PROTERRA

TECHNICAL SERVICE BULLETIN

ISSUE DATE:	11-2-2020
SERVICE BULLETIN SUBJECT:	800 Volt Rear Coolant Hose Retrofit
VINs or MODELS AFFECTED:	Service Specified Buses
COMPLETE BY:	Next Service Opportunity
SERVICE BULLETIN #:	SC-20-155
Labor Operation Code:	CC45Z

800 VOLT REAR COOLANT HOSE RETROFIT

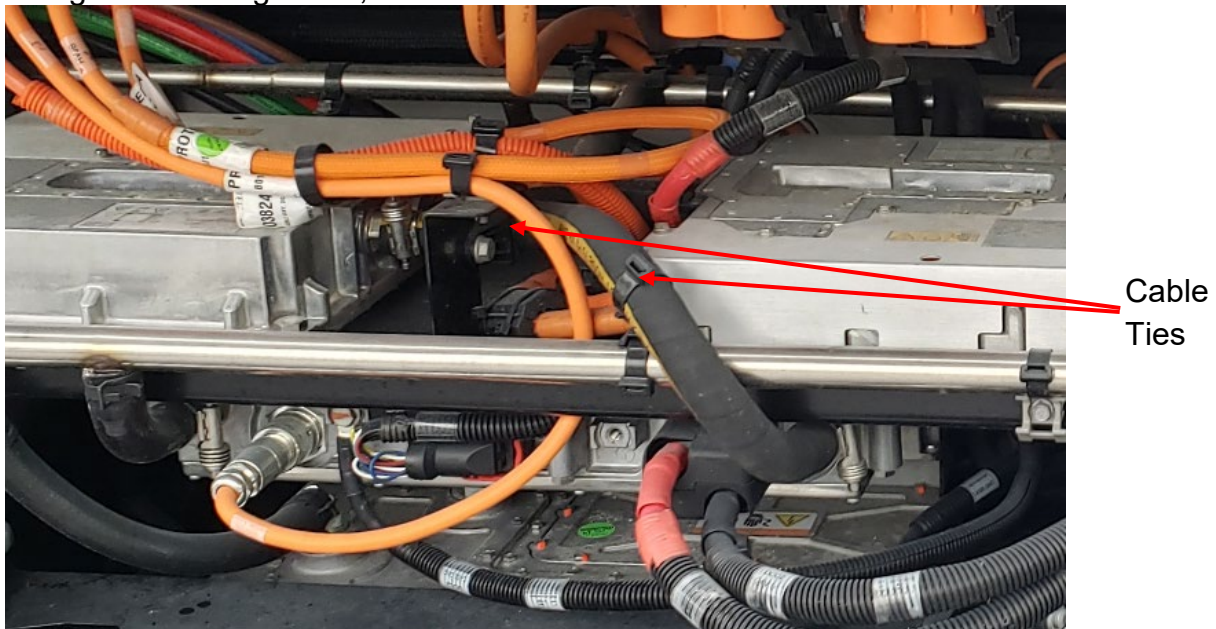
1. Complete the Proterra approved Lockout/Tagout procedure to make the bus safe for work.
2. Using a Catch Pan, drain the power electronics coolant loop so that the rear coolant hose may be removed for replacement.

3. Using Side Cutting Pliers, remove the two cable ties that secure the hose.

4. Using a Flat Blade Screwdriver, remove the Hose Clamps and the Hose from the bus.

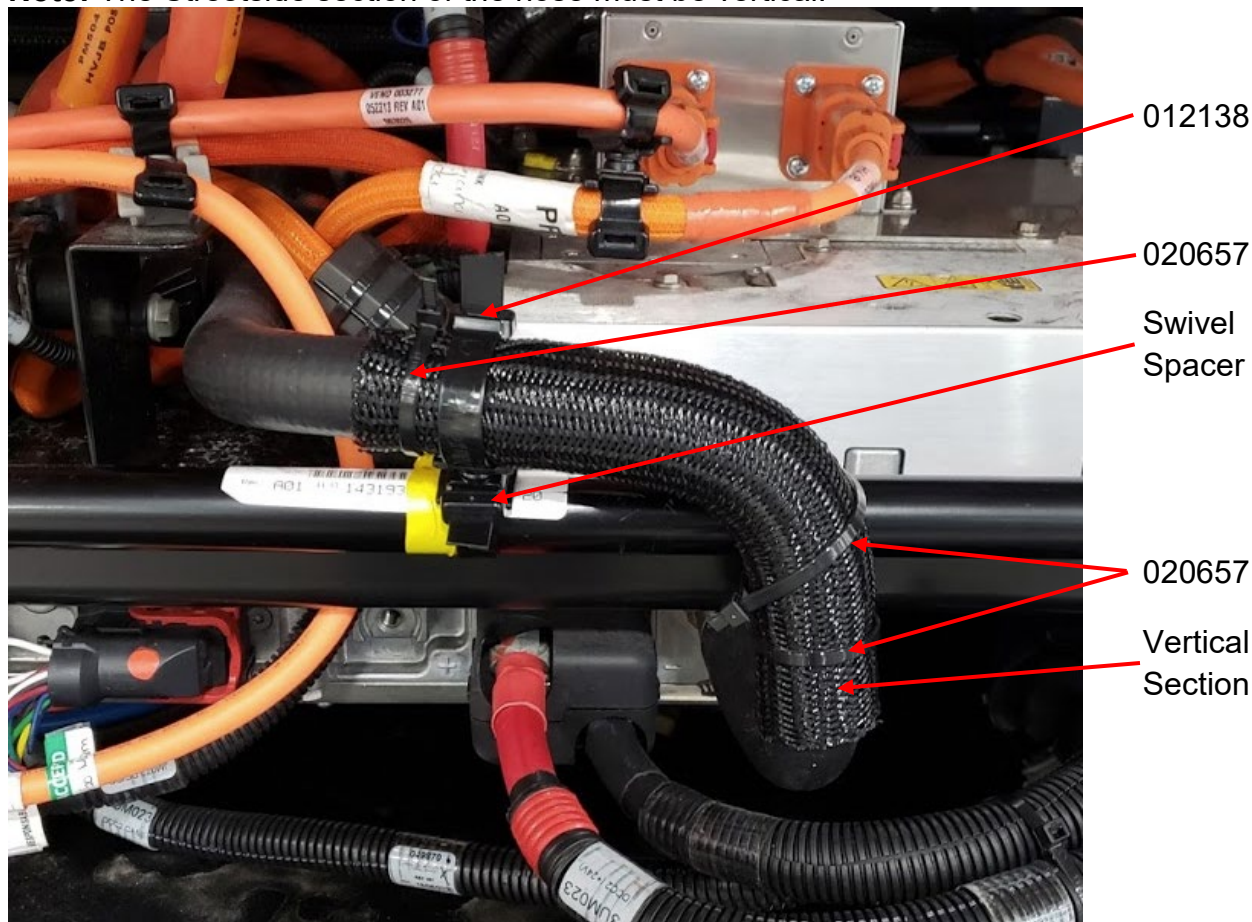
5. Wrap the Molded Hose (048059) with Pipe Wrap (045827).
6. Using a Flat Blade Screwdriver, install the Hose (048059) and Pipe Wrap (045827) in place of the original hose using the Hose Clamps that were removed earlier. Using Cable Ties (020657), secure the Pipe Wrap to the Hose.

Note: The Streetside section of the hose must be vertical.

7. Using Electrical Tape, wrap the steel tube even with the Streetside end of the Lenze. Using Cable Ties (012138), secure the Cable Tie Mount and Swivel Spacer to the Hose and steel tube on the electrical tape as shown in the previous photograph. Secure the Hose to the steel tube with a Cable Tie leaving a small gap between the Hose and steel tube.

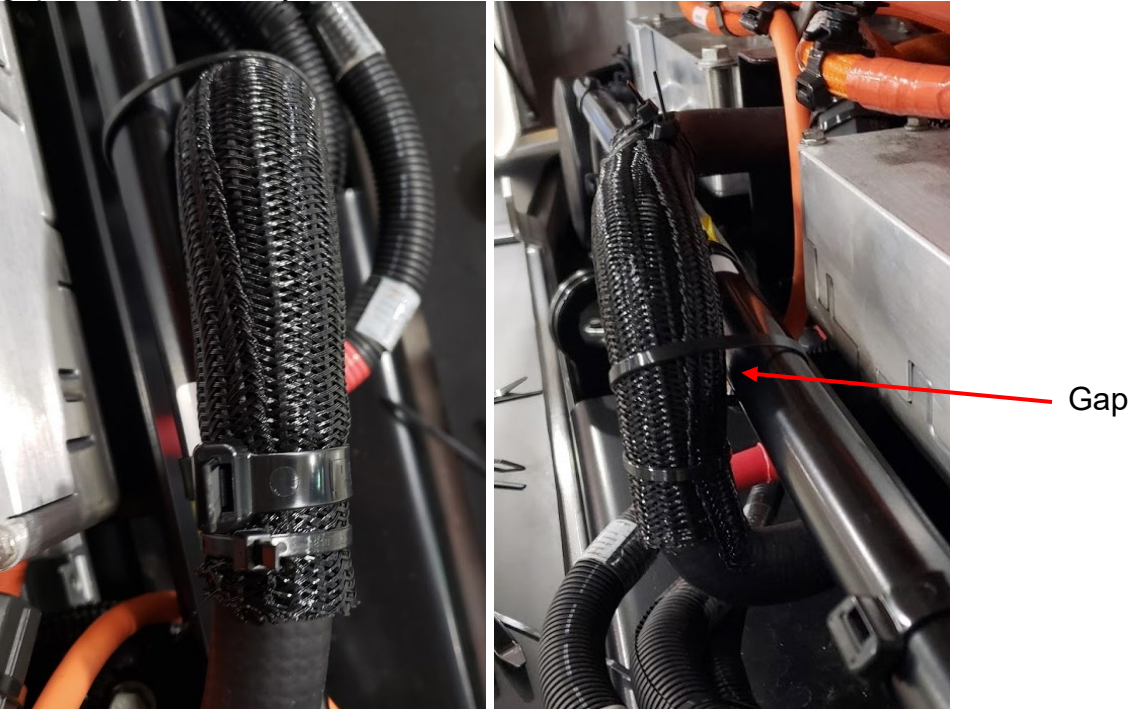
8. The following photographs show top and Curbside views of the completed Hose (048059) installation.

Note: Do not overtighten the Cable Tie (020657) shown in the second photograph. Leave a gap of approximately 5mm between the Hose and steel tube.
